RE: NORTHPORT EXPANSION CONSENTS – RESPONSE TO SECOND REQUEST FOR INFORMATION

**RE: NORTHPORT EXPANSION PROJECT (APP.005055.38.01 & LU2200107) – RESPONSE TO S92(1)
REQUEST FOR INFORMATION**

This is a response to the two requests for information (RFIs) dated 19 December 2022 and 2 February 2023 respectively. The response is structured according to the headings and item numbers in the two RFIs.

Figure 3.11 Measured (top) and model (bottom) depth change after one year from 2016 to 2017.

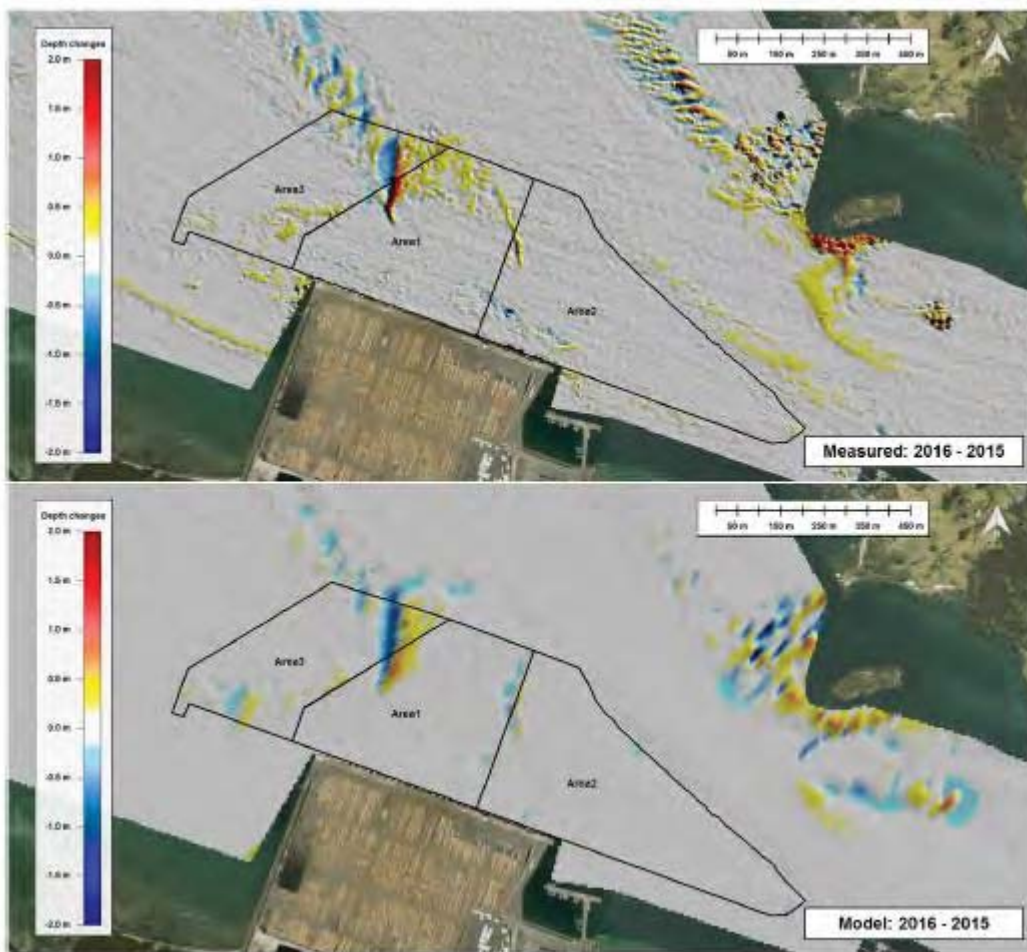
28.1 MO has confirmed that long-term morphological validation was completed for the input reduction. Details on the morphological model validation is presented in MetOcean Solution (2018b) (see **Attachment 13**). The calibration and validation of the morphological model was achieved by qualitatively and quantitatively comparing measured and modelled morphological changes.

- 28.2 Single beam survey data from 2007 to 2014 were examined to better understand the infilling process occurring within the swinging basin at Northport. The Delft3D morphological model was then calibrated for changes observed between 2016 and 2017. Qualitatively, model results show a good agreement spatially with the measured morphological changes, with the model capturing the migration of Snake Bank into the swinging basin and the succession of erosion and accretion along the southern margin of bank (see Figure 3.11 below).

- 28.3 The high degree of stability observed elsewhere in the channel was relatively well reproduced in the predictions, as is the strong activity over the deep area adjacent to Motukaroro Island. Quantitatively, the accretion of sand from the tip of Snake Bank into the swinging basin by bedload transport is somewhat under-estimated. It is likely that a lack of resolution in the model grid resulted in decreasing bed slope gradients which influenced greatly the bedload component of the sediment transport. Irrespective, within the order of magnitude of errors expected for hydrographic surveys, the model showed a good capability in predicting realistic volumetric infilling rates within Areas 1 to 3; +8,128 m³ and +3,658 m³, respectively (see Table 3.3 below).
